County of Fairfax, Virginia

Re: Interpretation for SEA 87-D-025, Vinson Hall Corporation, Tax Map 31-3 ((1)) 83 and 77A (6811 Beulah Road): Site Modifications, Garage, Parking, Retaining Walls and Limits of Clearing and Grading

Re: Interpretation Request – Vinson Hall (006713-SP-01 & SEA 87-D-025)
Tax Map: 031-3 ((1)) 0083 and 0077A

EXHIBIT A

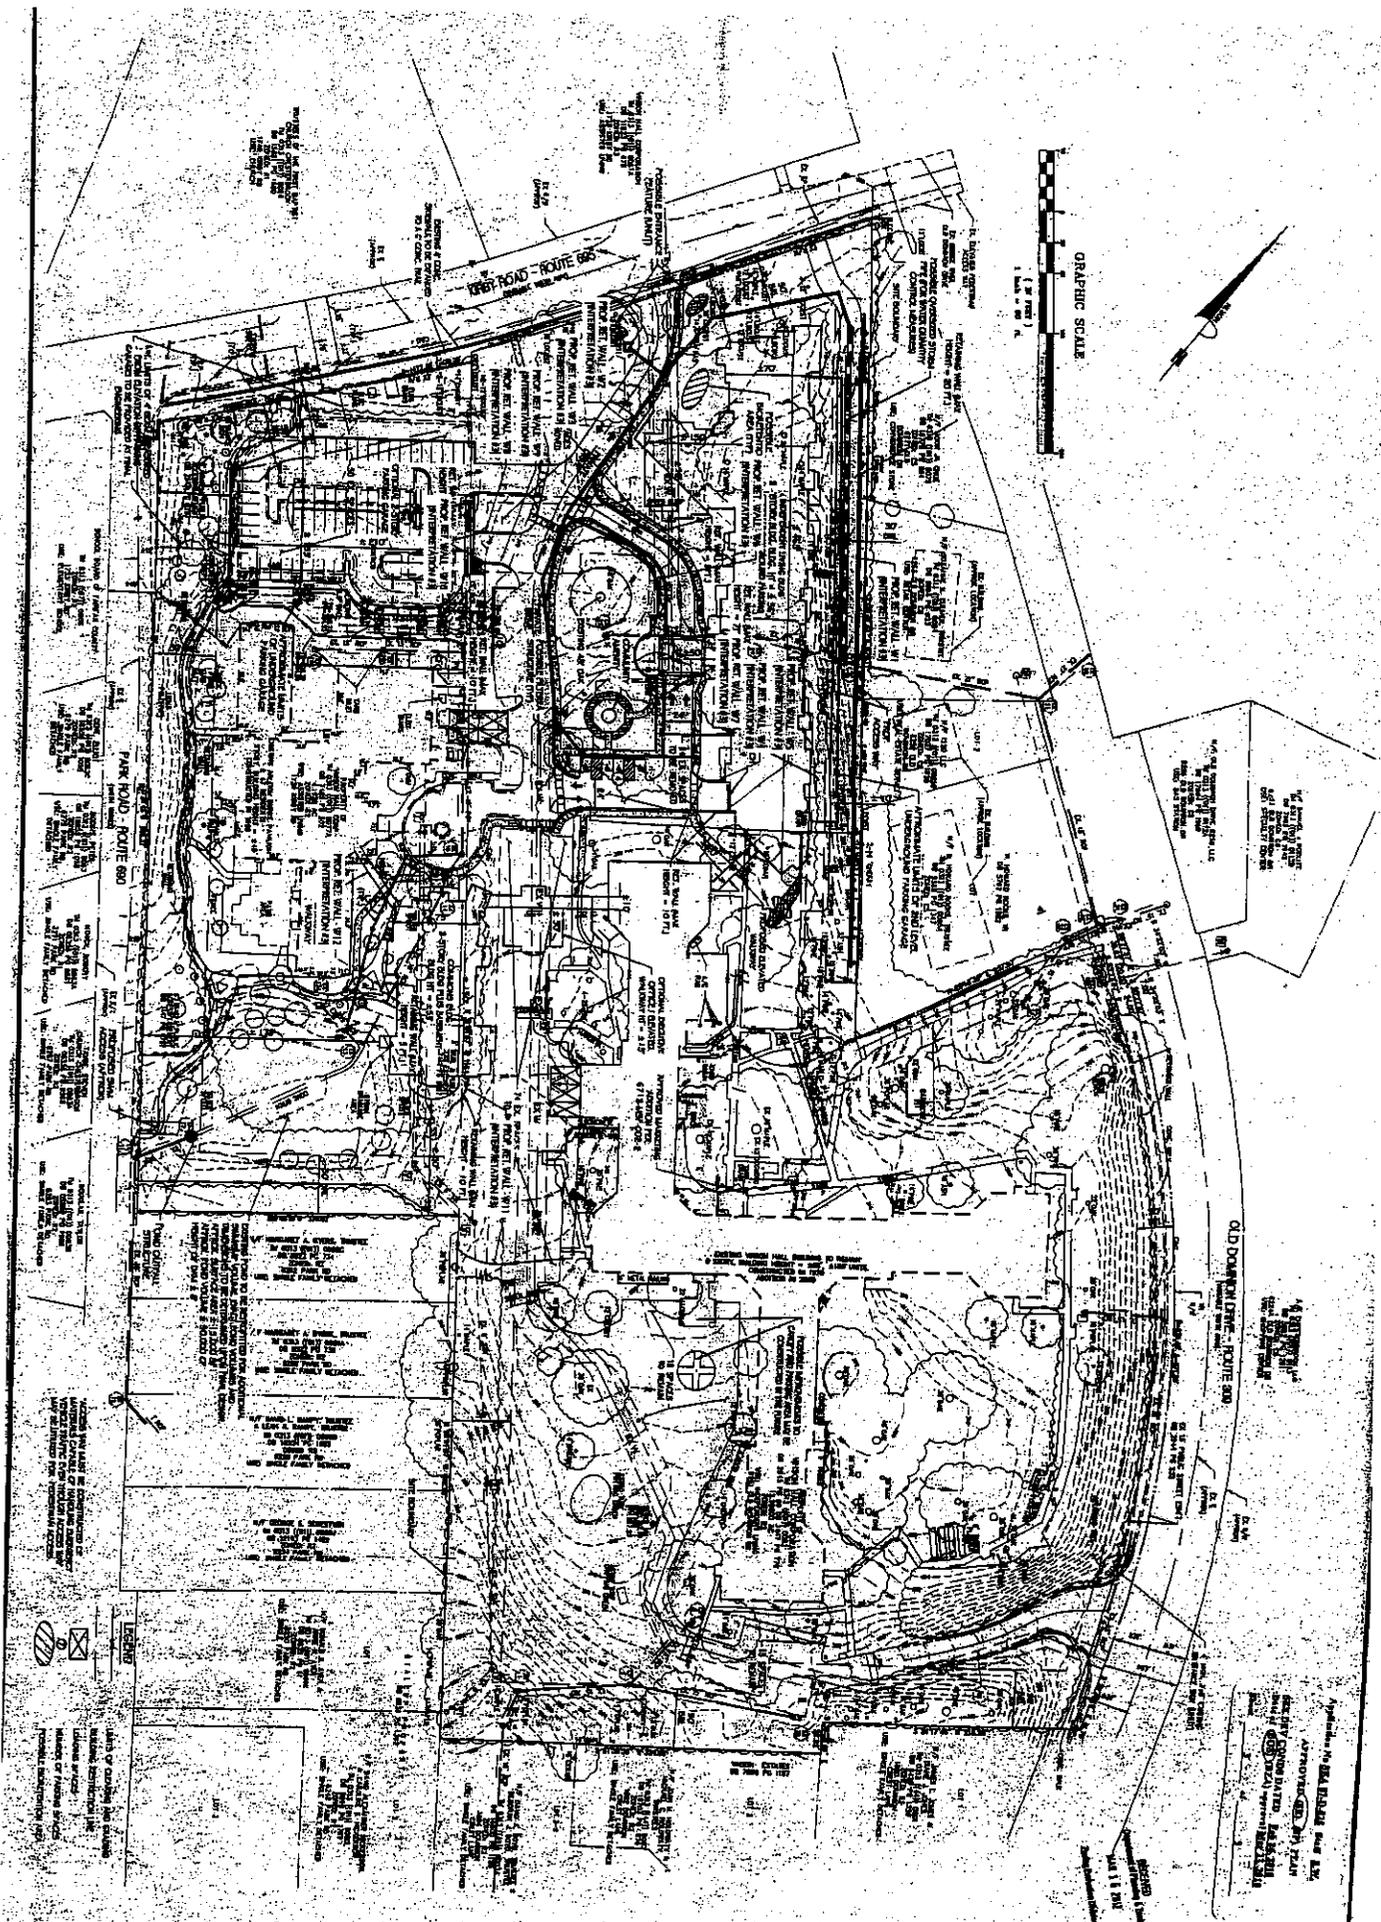
The SEA plan illustrates on sheet 3 that the proposed Independent Living Building shall include a 2-story underground parking garage and a corresponding underground ramp which runs parallel to the eastern property line. The limit of the garage is labeled as "+/- 10'" from the said property line. Sheet 1 states that this parking garage shall include 112 parking spaces.

The SEA includes a note on sheet 3 of 6 of the "Layout Plan" which states, "Possible improvements to canopy and parking area may be constructed in the future." Pursuant to this note the owner would like to provide approximately 14 "head-in" parking spaces and 2 "head-in" van spaces as shown on the attached exhibit. The 6 spaces and van parking will be implemented by restriping the existing pavement and will not require any clearing, grading or removal of existing vegetation. The proposed work for the 8 additional spaces will require approximately 0.06 acres of additional disturbed acres.

The SEA plan indicates multiple retaining walls with approximate heights throughout the site as shown on sheet 3 of 6 of the "Layout Plan". Upon final engineering exact heights, lengths and locations have since been determined based on the topography of the site. Furthermore, additional walls have been proposed in order to sufficiently provide a safe and usable development.

As such, it is my determination that eliminating one level of the underground parking garage and expanding the footprint of the garage beneath the proposed Independent Living Building, as discussed above and depicted on Exhibit B, would be in substantial conformance with SEA 87-D-025, provided that the garage remains completely underground and subject to the approval of the Department of Public Works and Environment Services (DPWES).

It is my determination that the proposed 16 parking spaces would be in substantial conformance with the SEA Plat, provided that there is no disturbance of the 50-foot vegetative buffer adjacent to the residences along the southern property line, and a minimum of 40% open space is maintained on the site in accordance with SEA 87-D-025.

It is my determination that the proposed modifications to the retaining walls and adjustments to the limits of clearing and grading, as described above, and as shown on Exhibits A, B and D, would be in substantial conformance with SEA 87-D-025, provided that a minimum of 40% open space is maintained on the site, supplemental landscaping is installed in areas of the limits of clearing and grading that are disturbed, the finish materials of the retaining walls are consistent with those shown on the submitted exhibit, and provided the retaining walls are approved by DPWES. Supplemental landscaping shall be as determined by Urban Forest Management, DPWES.

INTERPRETATION EXHIBIT D

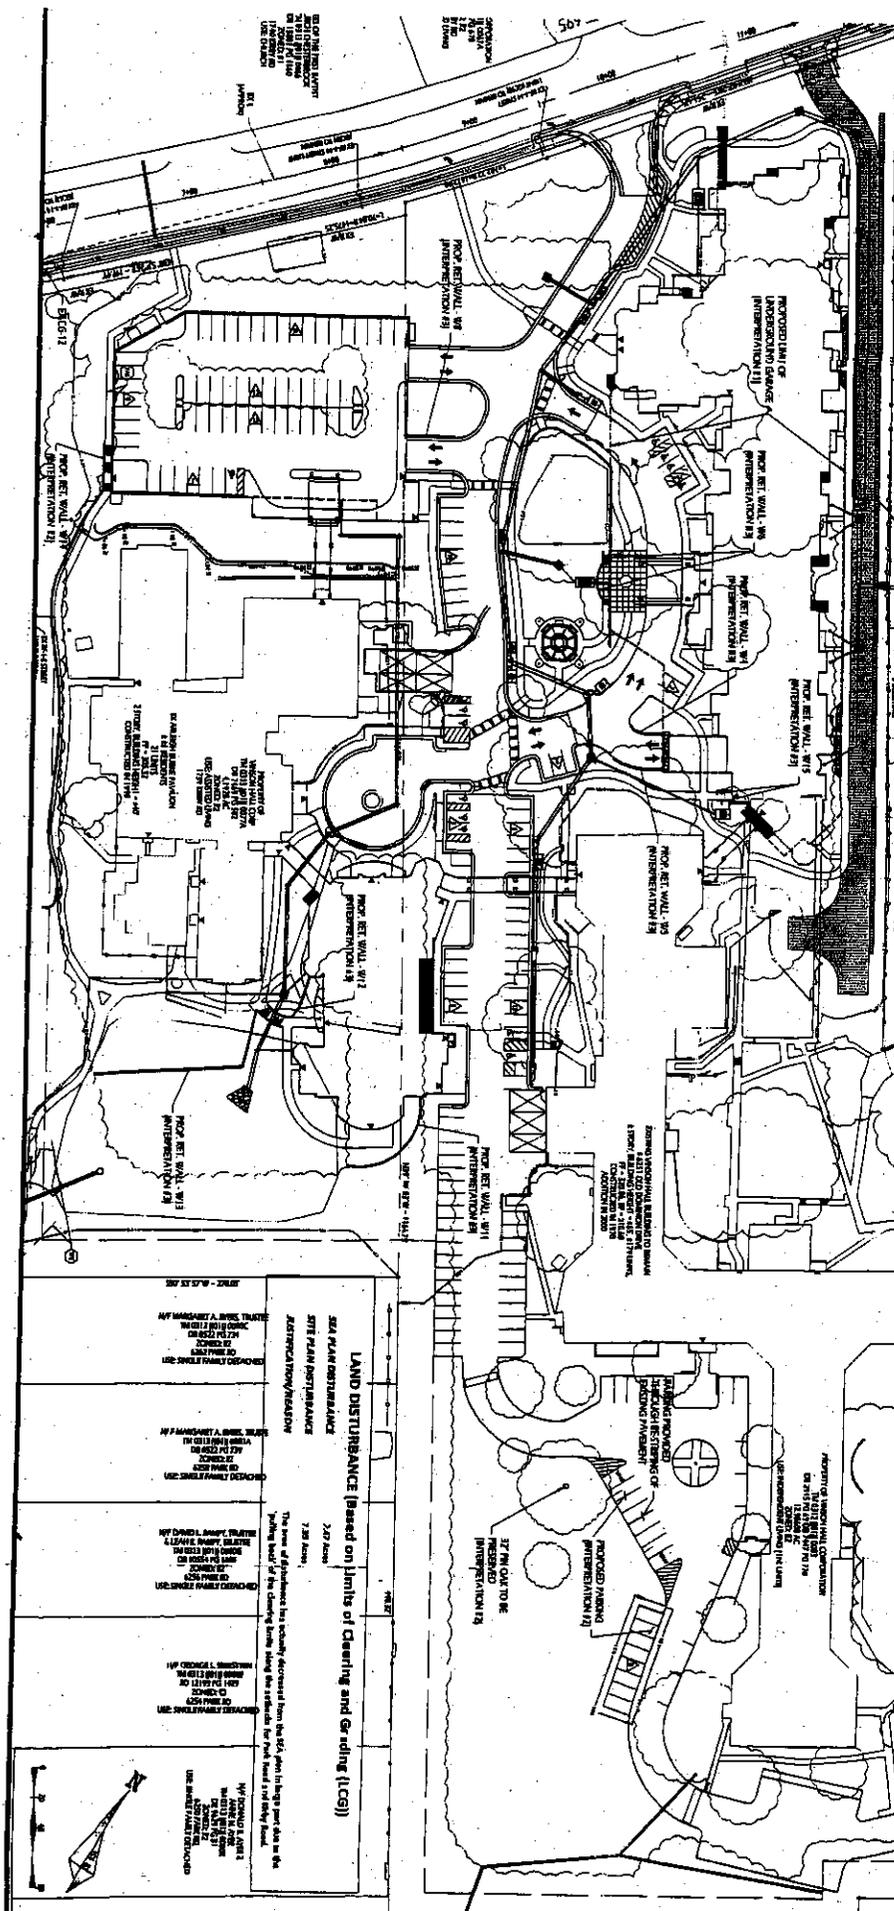
ID	SEA PLAN		SITE PLAN		JUSTIFICATION/REASON
	Length	Height	Length	Height	
W1	545'	20' MAX	586'	23.8' Max (15.5' Avg)	Final building architecture while maintaining a transversable route for emergency vehicles and the constraints of the existing conditions adjacent to the property.
W2	30'	3'	—	—	Wall eliminated with final engineering.
W3	30'	3'	—	—	Wall eliminated with final engineering.
W4	25'	10'	36'	11.2'	Final building architecture and the existing 48" oak tree that is to be saved.
W5	33'	10'	47'	11.2'	Final building architecture and the existing 48" oak tree that is to be saved.
W6	174'	7'	205'	5.9' Max. (3.9' Avg)	Final engineering adjusted the configuration within the courtyard area.
W7	63'	7'	—	—	Wall eliminated with final engineering.
W8	34'	12'	17'	2'	—
W9	32'	12'	—	—	Wall eliminated with final engineering.
W10	30'	10'	—	—	Wall eliminated with final engineering.
W11	38'	10'	81'	14' Max (8.5' Avg)	Final engineering of the SWM pond and it's proximatey to the proposed building and the existing parking lot and it's related grades.

W12	16'	5'	46'	10'	Required in order to provide internal sidewalk access from existing building to prooosed building.
W13	—	—	160'	15.4' Max (8.2' Avg)	Final engineering of the SWM pond and it's proximatey to the existing building and the internal sidewalk access and the wall provides useable space behind the Arleigh Burke Pavilion.
W14	—	—	58'	12.4'	Final architecture of the parking garage and the need to maintain the existing internal sidewalk access.
W15	—	—	10.5'	5.85'	Final building architecture provided external door from stairwell between garage and first floor.
W16	—	—	285'	8.1'	Required in order to provide sight distance under current design criteria.

The final site plan parking counts are different from the SEA parking counts for a number of reasons. The final architecture for the community building (Commons Building) and the overhead walkway and it's related support columns caused us to have to relocate a number of spaces. After the completion of a value engineering exercise, the 2 story underground parking garage below the Independent Living Building was changed to a 1 story garage with a larger underground footprint that further impacted the surface parking. When factored in with the existing tree save requirements, it necessitated us to adjust the parking layout from the original approved SEA plan but still maintain the overall integrity and intent of the approved SEA plan. Also, it is expected that the internal parking lot landscaping has been maintained as we have substituted lost spaces for new spaces.

EXHIBIT B - SITE PLAN

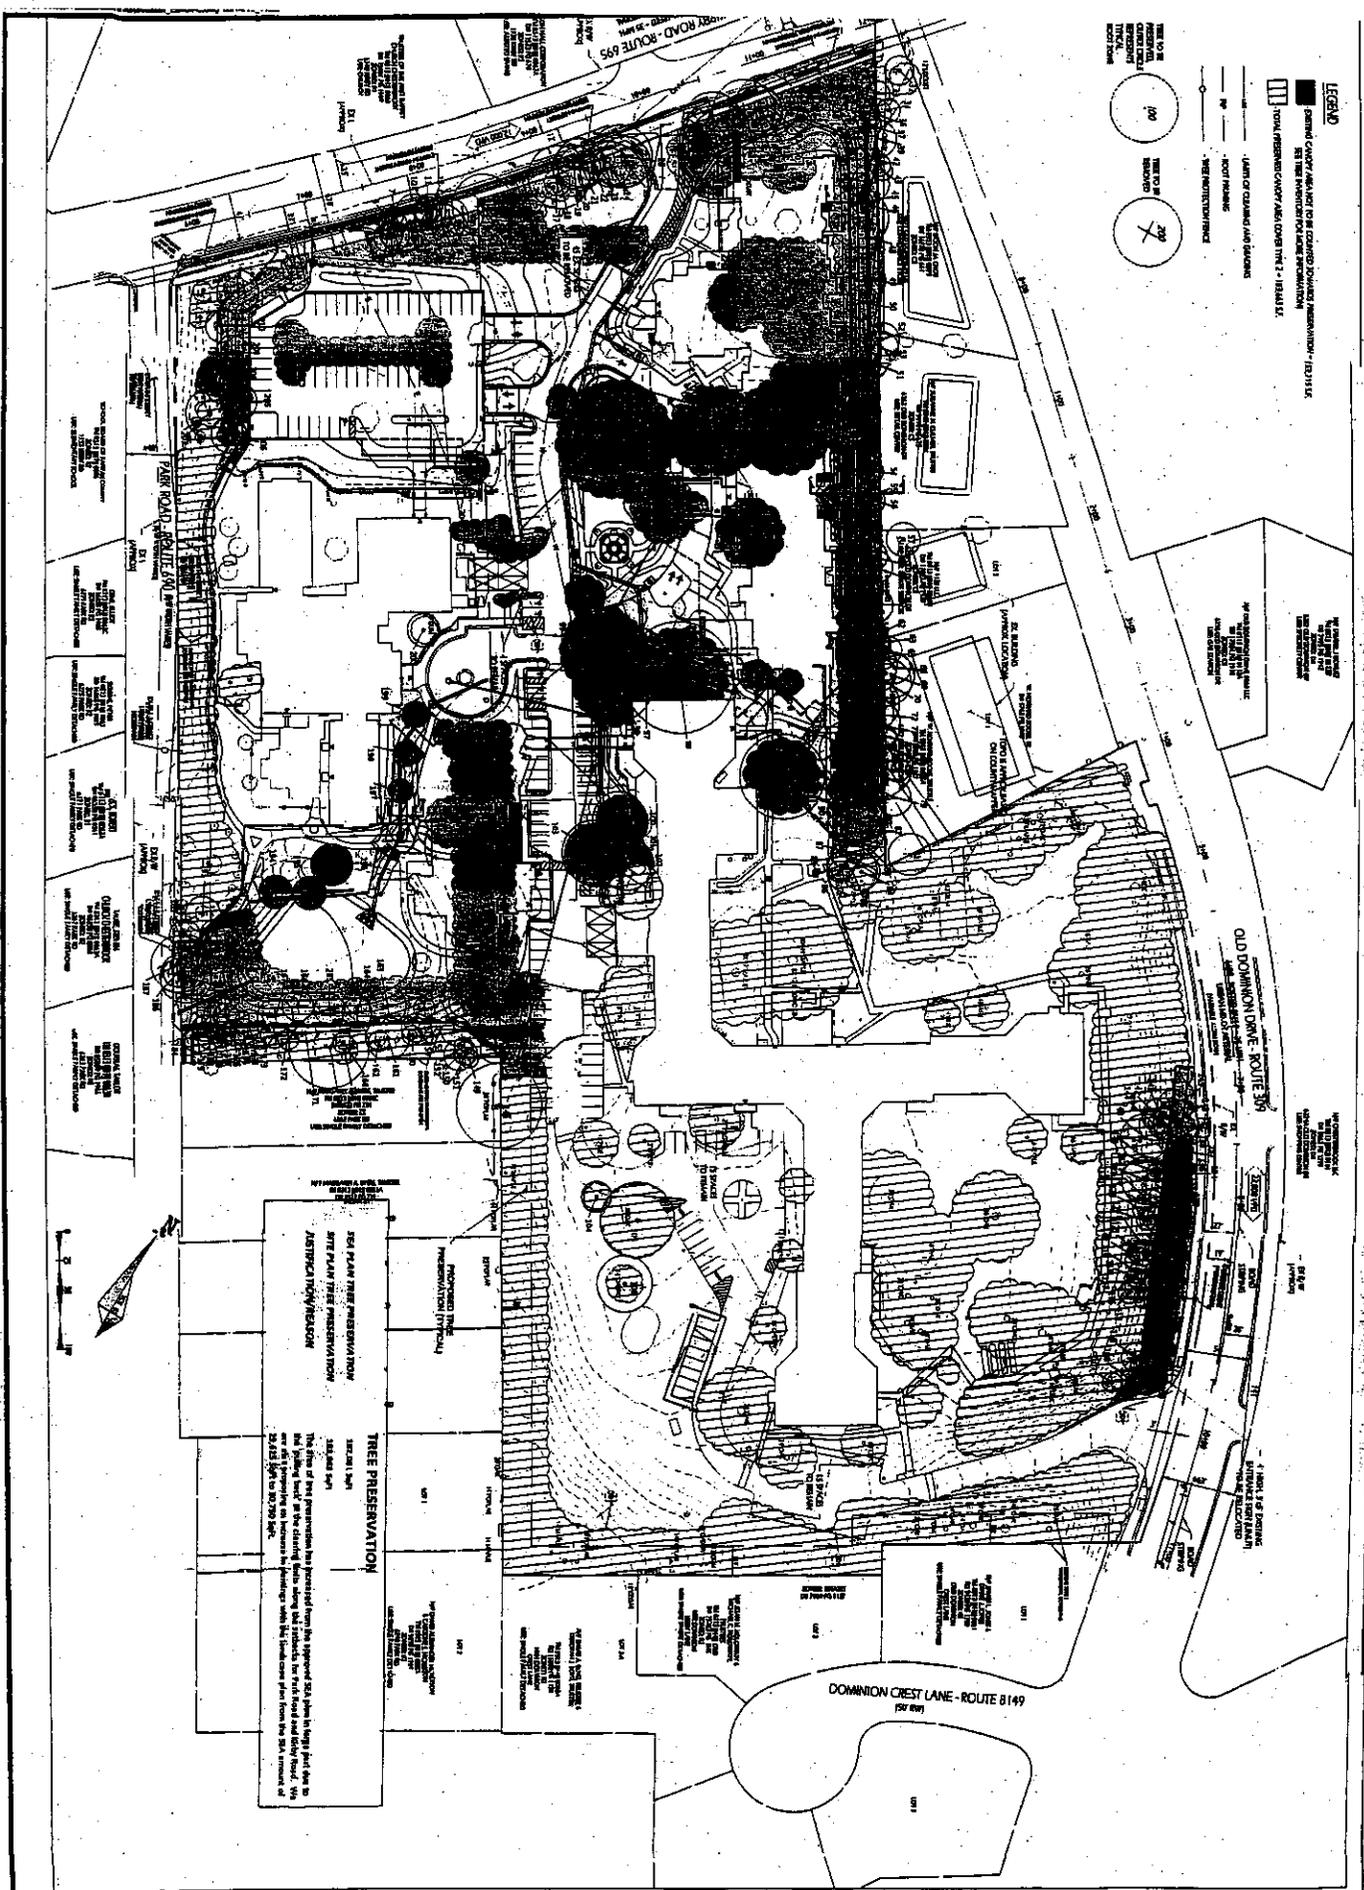
As I understand it, you are proposing to expand the footprint of the parking garage beneath the new Independent Living Building and eliminate the second level of the approved underground garage. The result of this modification will be an expanded single-level underground garage with 127 parking spaces. You state in your letter that the location of existing above-ground utilities, the proximity of the proposed underground ramp to a storm drain pipe and retaining wall, along with construction costs, prohibit the construction of a two-level garage beneath this building.

You also propose to provide 16 surface parking spaces, 14 head-in parking spaces and two head-in van accessible parking spaces, north of the main drive and within the circular driveway just south of the entrance to the existing Vinson Hall Building. A note on Sheet 3 of 9 of the SEA Plat shows this area as a location where "Possible Improvements to Canopy and Parking Area May Be Constructed In The Future." Eight of the proposed head-in spaces will be new construction and will require approximately 0.06 acres of additional land disturbance. The remaining eight spaces, consisting of six head-in and two head-in van spaces, will be implemented by restriping the existing pavement and will not require any clearing, grading or removal of existing vegetation. At build-out, a total of 389 parking spaces will be provided in accordance with Exhibits B and D.

The third question is whether modifications to the quantity, location, size, length and heights of on-site retaining walls, and corresponding modifications to the limits of clearing and grading at the site's Old Dominion Drive frontage are in substantial conformance with the SEA Plat and development conditions. You have submitted an exhibit entitled, "Vinson Hall – Retaining Wall Materials," demonstrating general earth tone colors and segmented block materials that would be used. According to your letter and as noted on Exhibit D, final engineering on the site has demonstrated the need to eliminate Walls 2, 3, 7, 9 and 10, as shown on the SEA Plat, and to install four new retaining walls: Walls 13, 14, 15 and 16. Wall 1 is proposed to increase in length from 545 feet to 586 feet and increase in height from 20 feet to 23.8 feet, at its highest point, with an average

height of 15.5 feet. Wall 4 is proposed to increase from 25 linear feet to 36 linear feet and increase in height from 10 feet to 11.2 feet. Wall 5 will increase from 33 linear feet to 47 linear feet and will increase from 10 feet in height to 11.2 feet in height. Wall 6 is proposed to increase in length from 174 feet to 205 feet and decrease in height from 7 feet to 5.9 feet. Wall 8 will decrease in length from 34 feet to 17 feet and decrease in height from 12 feet to 2 feet. Wall 11 will increase from 38 linear feet to 81 linear feet and increase in height from 10 feet to 14 feet. Wall 12 will increase from 16 linear feet to 46 linear feet and will increase in height from 5 feet to 10 feet. Wall 16 is designed to improve sight distance at the Old Dominion Drive entrance and will measure 295 linear feet with a maximum height of 8.1. You have indicated that overall land disturbance on the site, based on the limits of clearing and grading, would be reduced from 7.45 acres to 7.35 acres with the proposed modifications.
